Product Update: Drive Belt Auto-Tensioner Pivot Bolt Replacement

Replace the auto-tensioner pivot bolt, and reroute the drive belt. On vehicles with A/C, install a new drive belt.

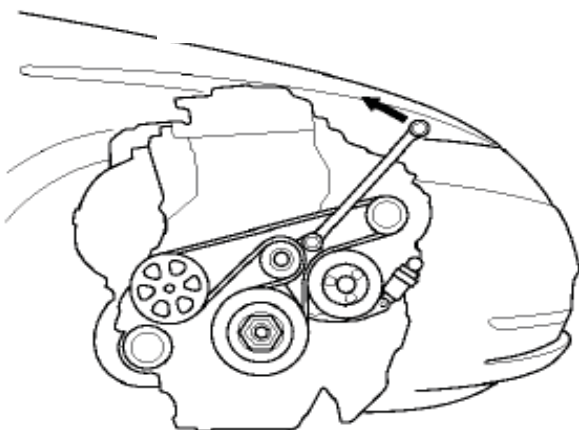
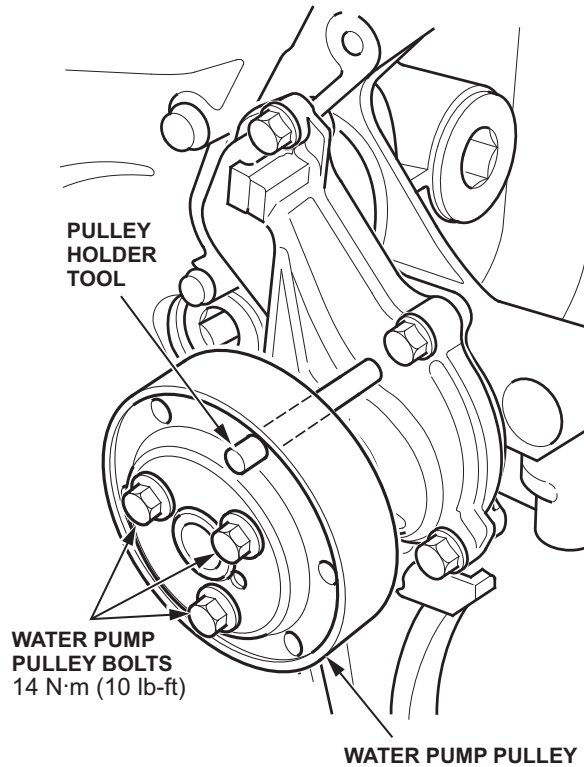
- On vehicles with A/C, route a new drive belt around the engine pulleys as shown below. On vehicles without A/C, route the original drive belt as shown in step 1.

- From above the engine, set a long-handled boxed-end wrench on the drive belt auto-tensioner. Slowly turn the wrench counterclockwise, and slip the belt over the auto-tensioner pulley. Release the auto-tensioner, and remove the wrench.
- Center-punch a completion mark below the 13th character of the engine compartment VIN:
 - Slide open the FRAME NUMBER door on the center cowl cover.
 - Use a long punch to reach the VIN.

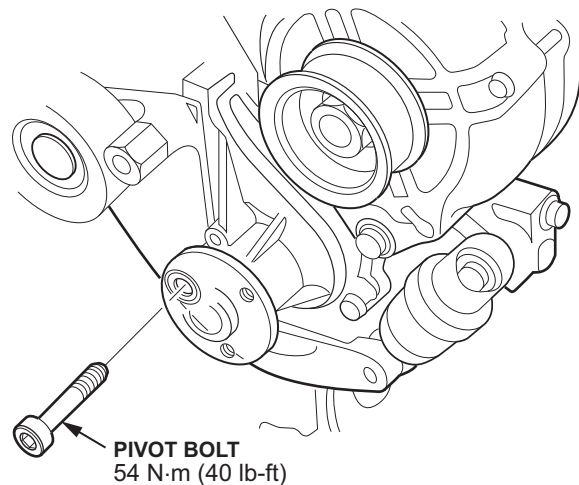
3. Remove the water pump pulley (three bolts).
4. Remove the pivot bolt from the drive belt auto-tensioner.

NOTE: In rare cases, the pivot bolt may be broken. If this has happened, remove the auto-tensioner, then remove the shank of the pivot bolt with Vise Grips or by drilling it out. *Do not try to repair the engine block using a TIME-SERT.* If you can't remove the shank of the pivot bolt, you would need DPSM approval to install an engine short block assembly.

- Install a new pivot bolt on the auto-tensioner, and torque it to **54 N·m (40 lb-ft)**.
